AR-07-1162

Southern Nuclear Operating Company
Vogtle Early Site Permit Application
Supplemental Response to Requests for Additional Information on Geology/Seismology

Supplemental Response to Geology/Seismology RAIs

Vogtle ESP Application

The resulting fits to the three data points are shown in Figure 1, located on the following pages, for each of the seven frequencies. The coefficients and equation are given at the top of each plot. Note that the red dashed line is a linear log-log line between the three data points.

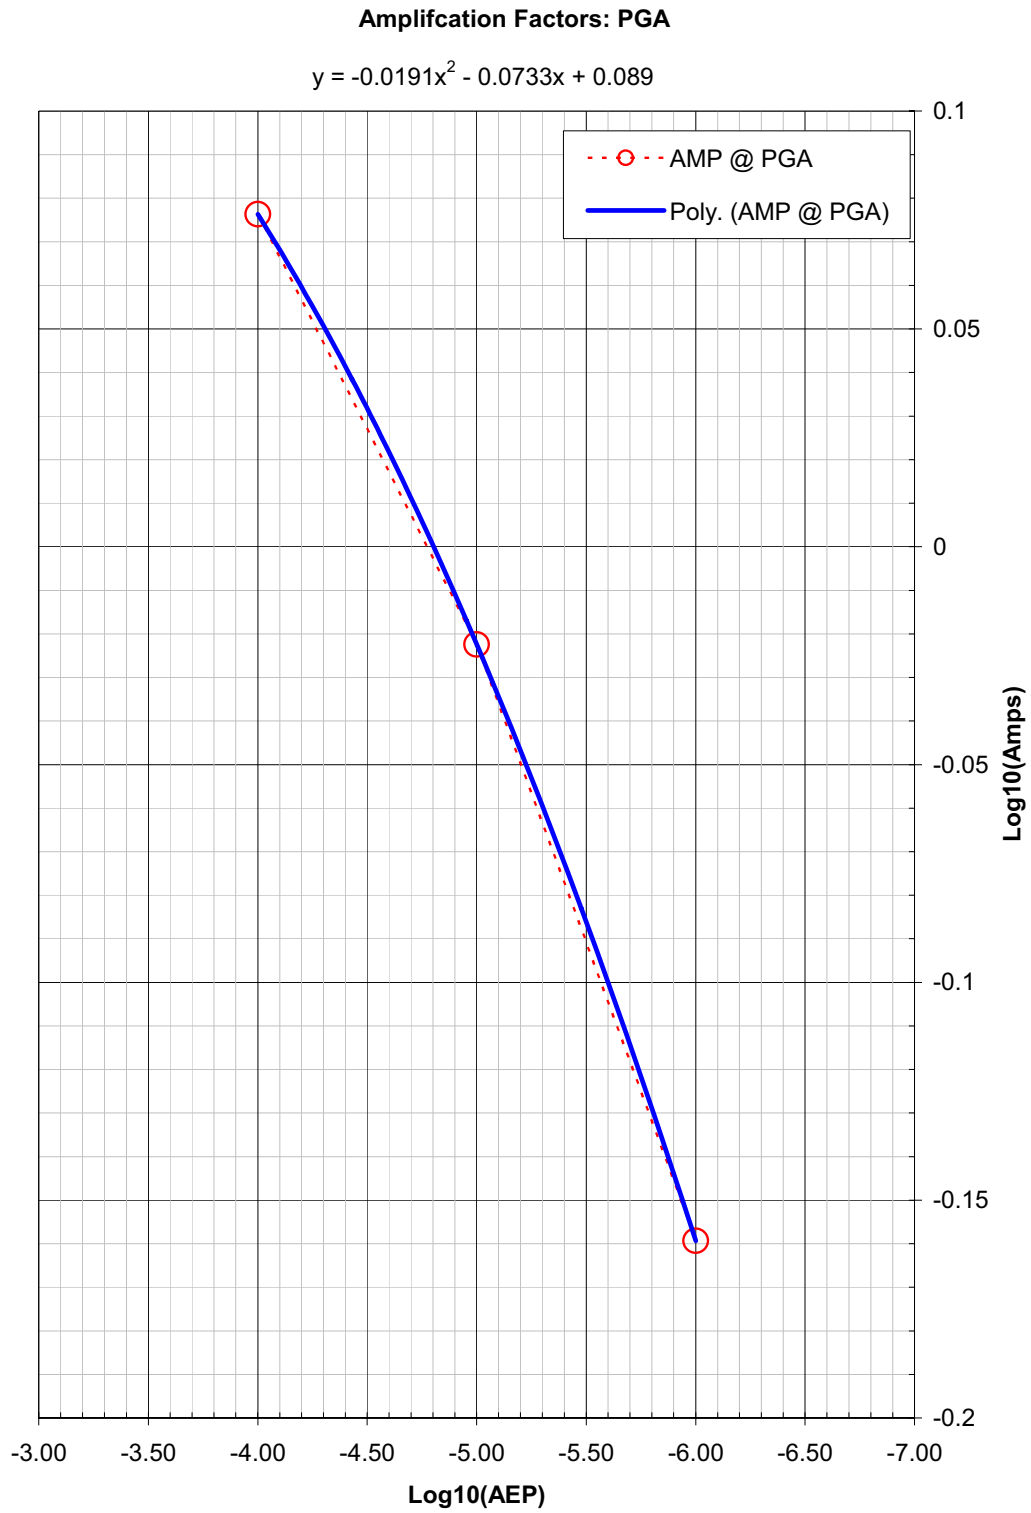
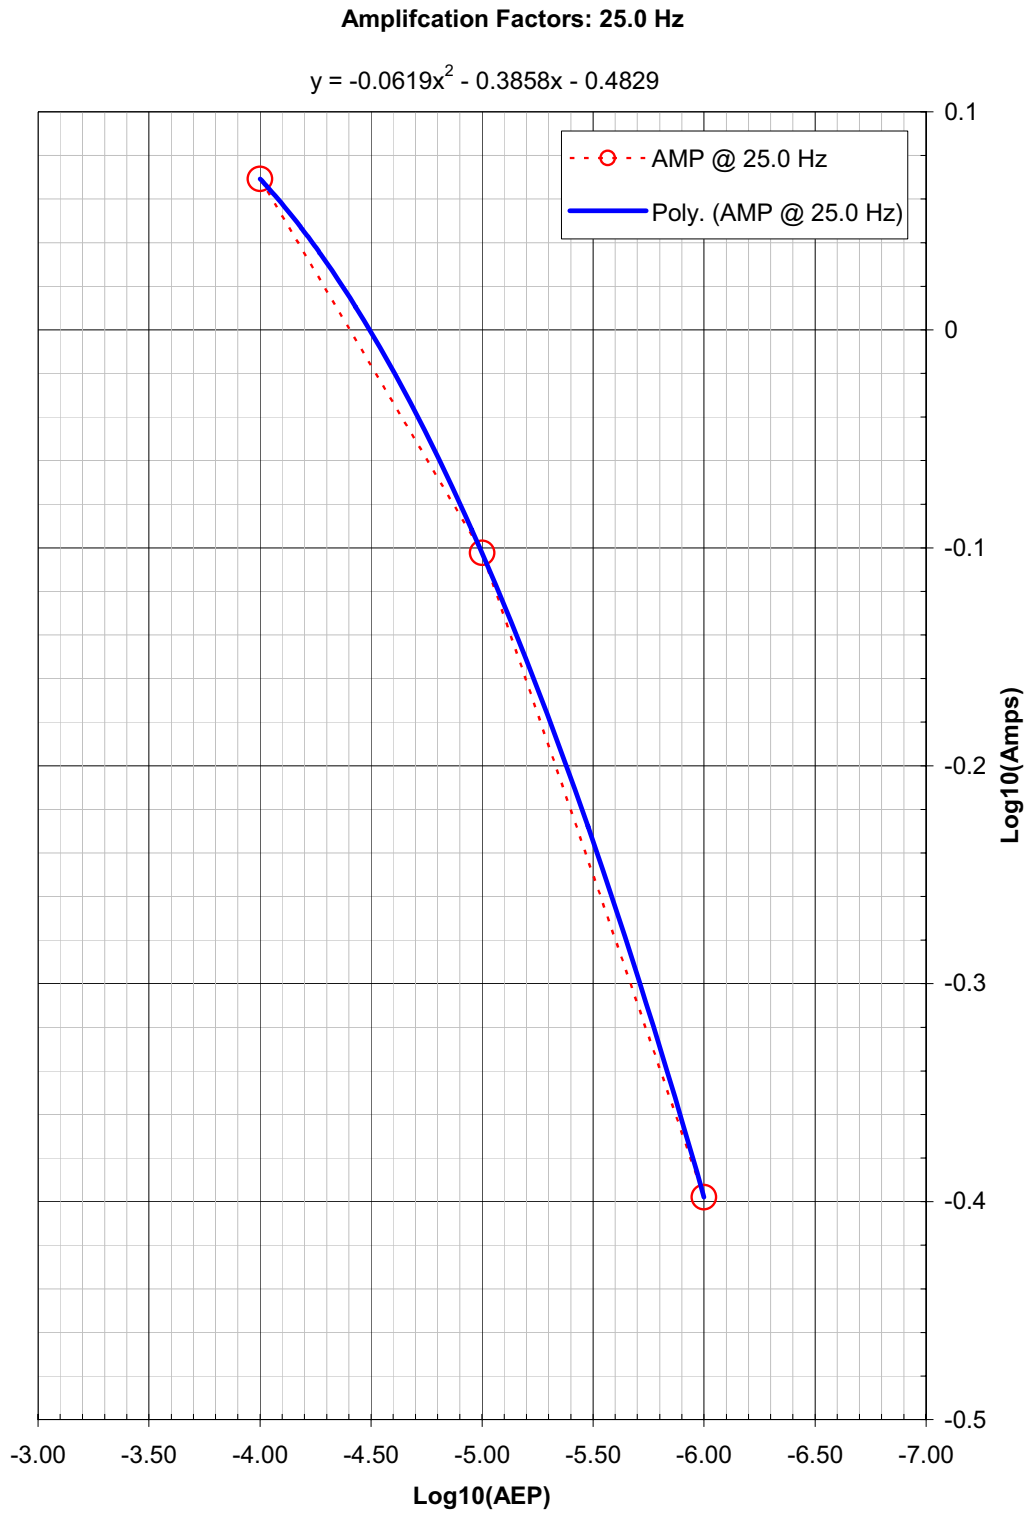
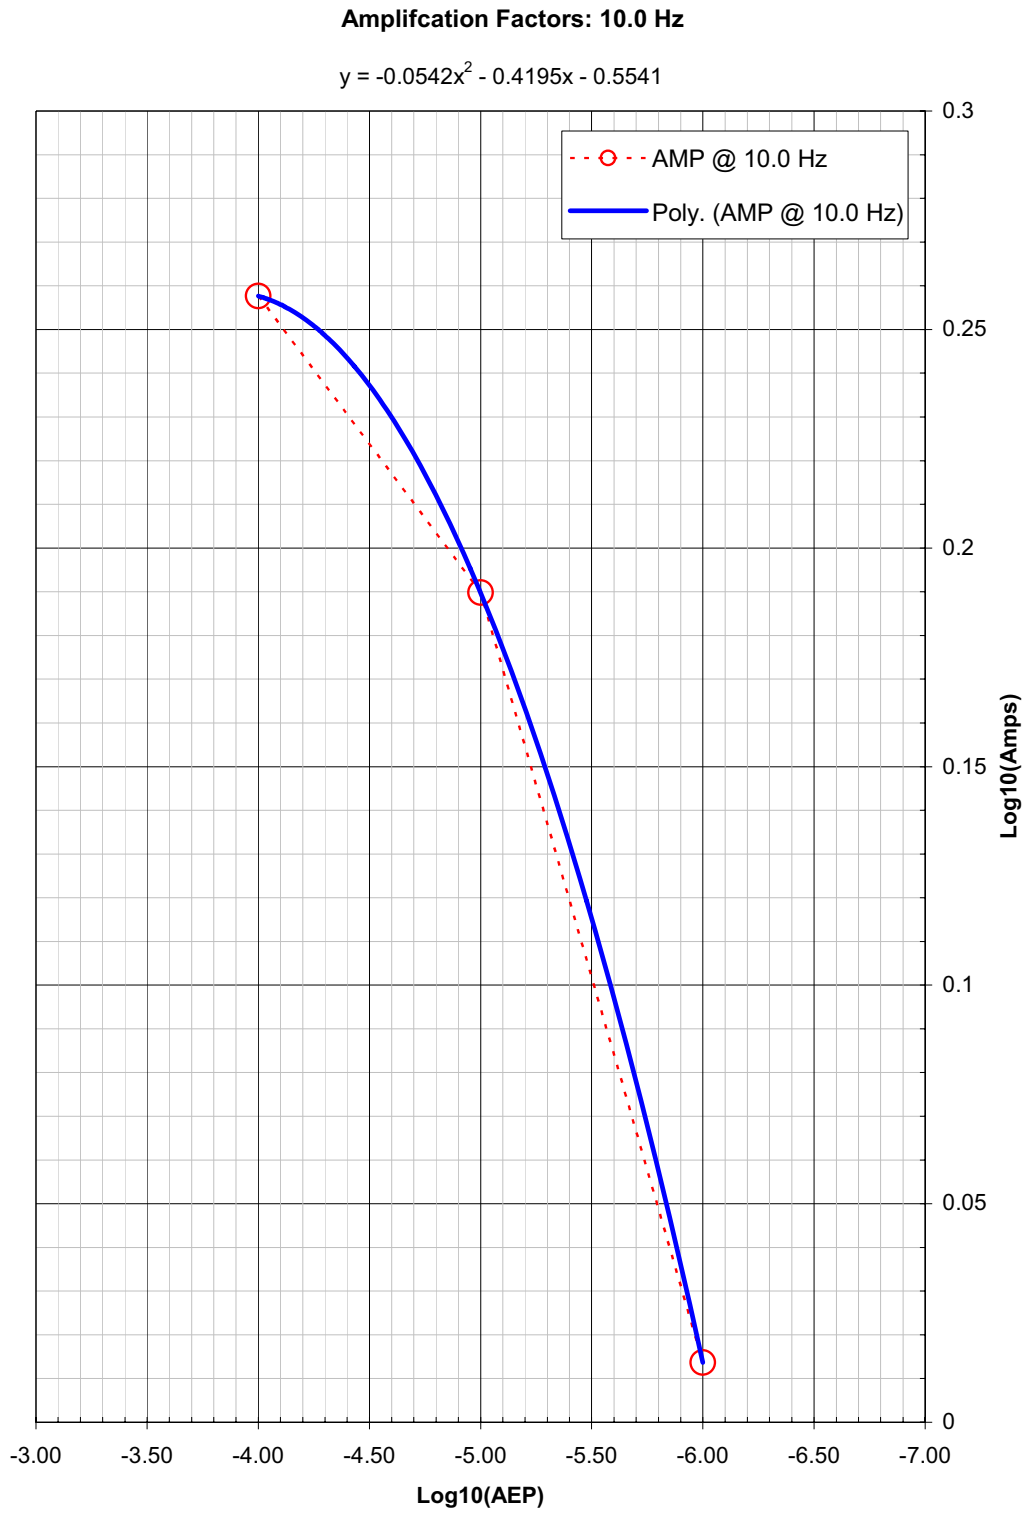
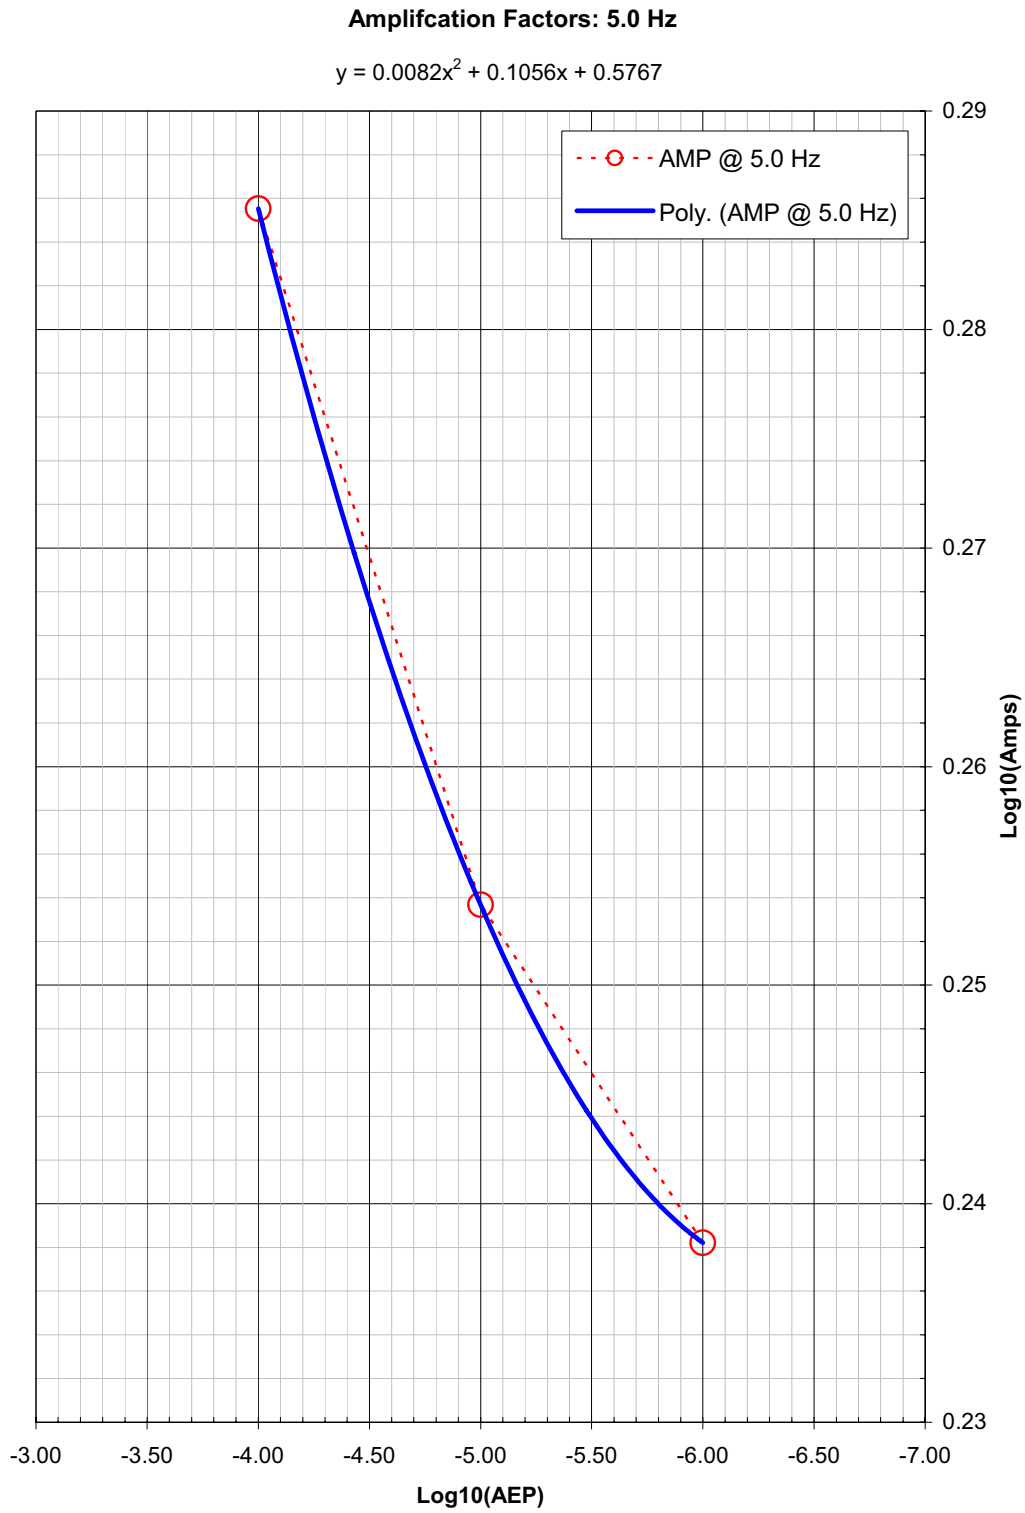
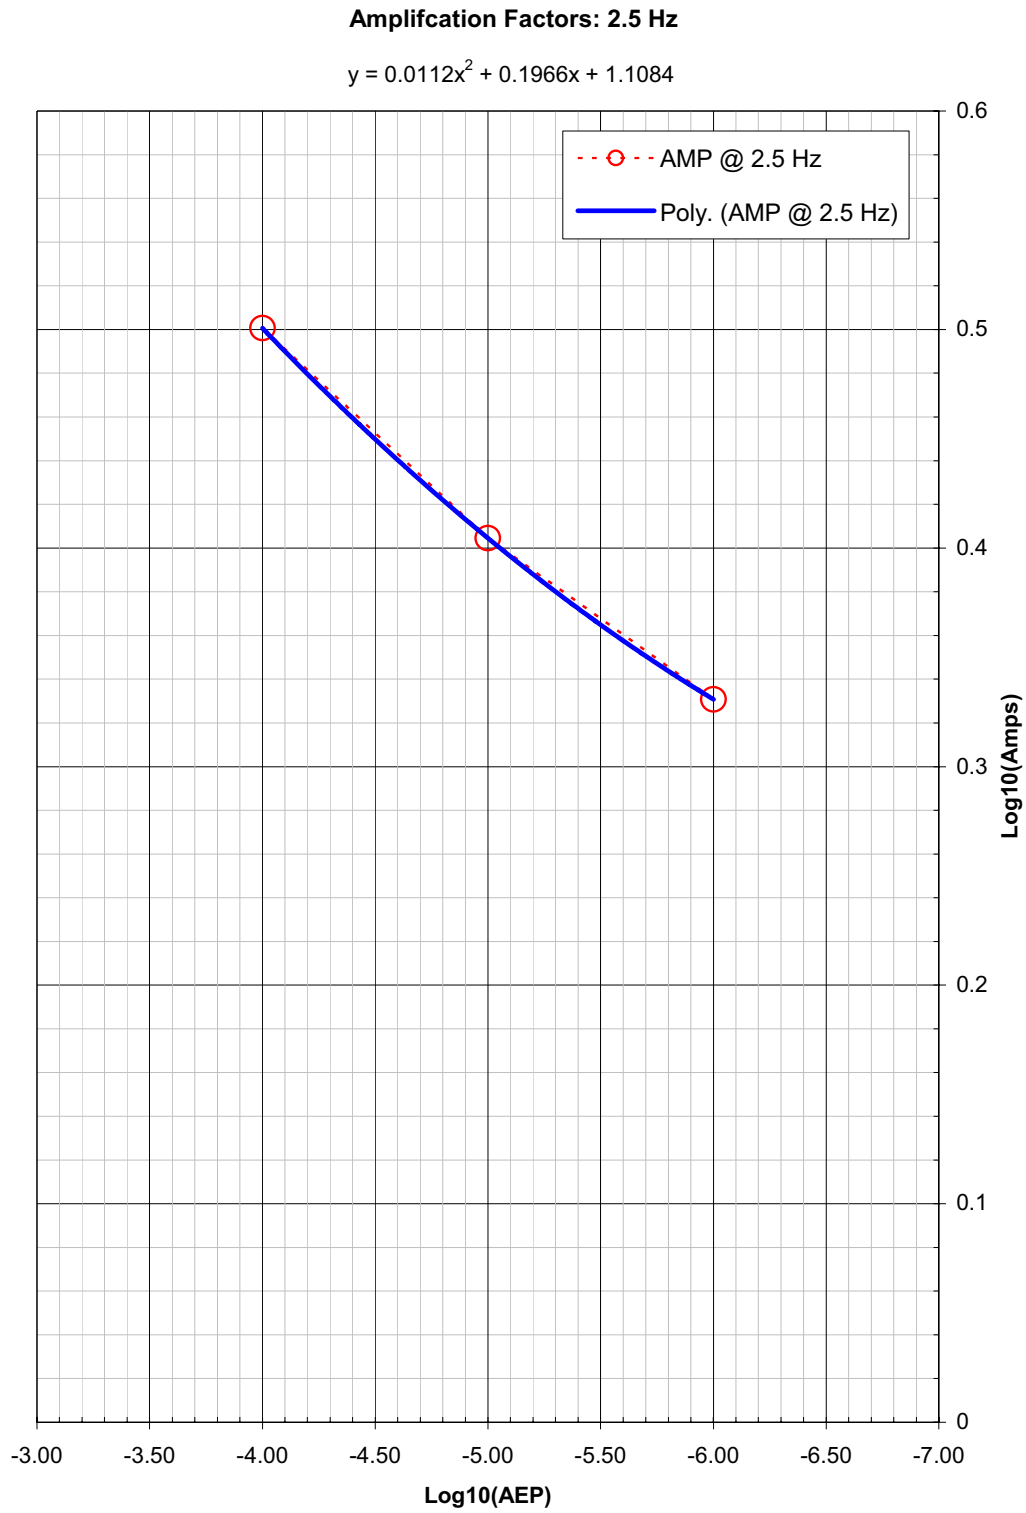
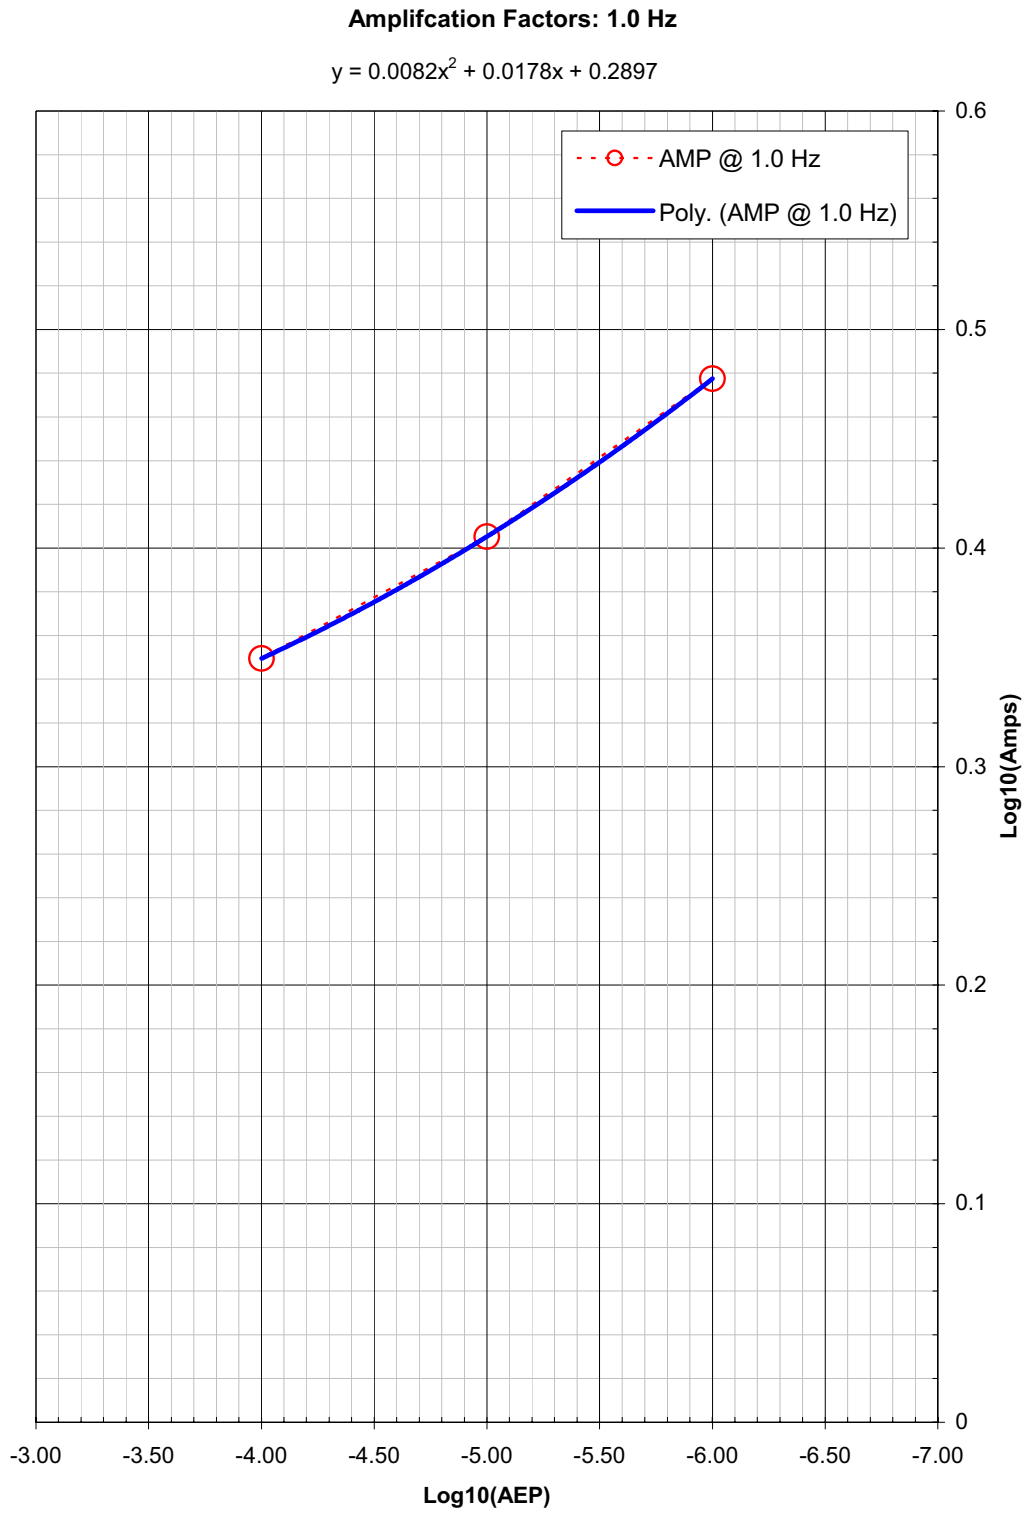
2.5.2-3 In response to this RAI, soil hazard curves were provided at three annual exceedence frequencies (10^{-4} , 10^{-5} , and 10^{-6}). However, in order for the staff to verify the adequacy of the SSE, soil hazard curves are requested at additional annual exceedence frequencies (i.e. at values between 10^{-4} , 10^{-5} , and 10^{-6}).

For each of the seven frequencies a quadratic equation was fit to the log (base10) of the spectral ratios (AMP) as a function of the log (base10) of the annual exceedence probability (AEP). Mathematically, this functional model is given as,
